**Subject:** Site Plan Review  
Pinckney Chrysler Dodge Jeep Ram

**Location:** 1295 E. Main Street/M-36 (Parcels # 4714-23-400-059)

We have reviewed a request for Site Plan approval for the expansion of the Pinckney Chrysler Dodge Jeep Ram dealership. This review focuses evaluates compliance with the site plan approval standards and Section 152.387 through 152.393 of the Village Zoning Ordinance.

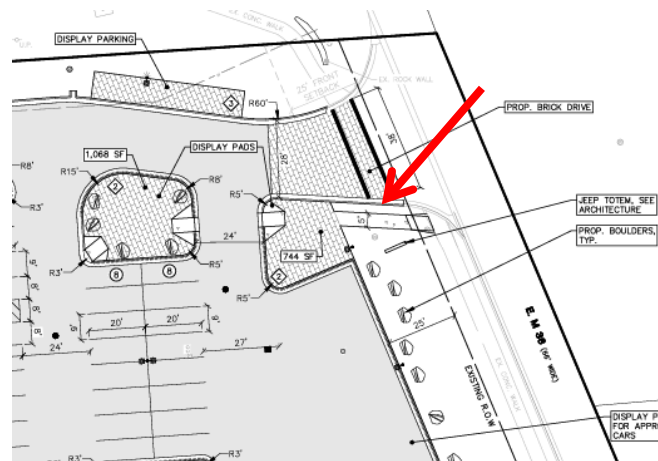
**A small gap remains and should be addressed to provide a continuous accessible connection, including a ramp at the crosswalk to the property to the east, as shown on the illustration to the right.**
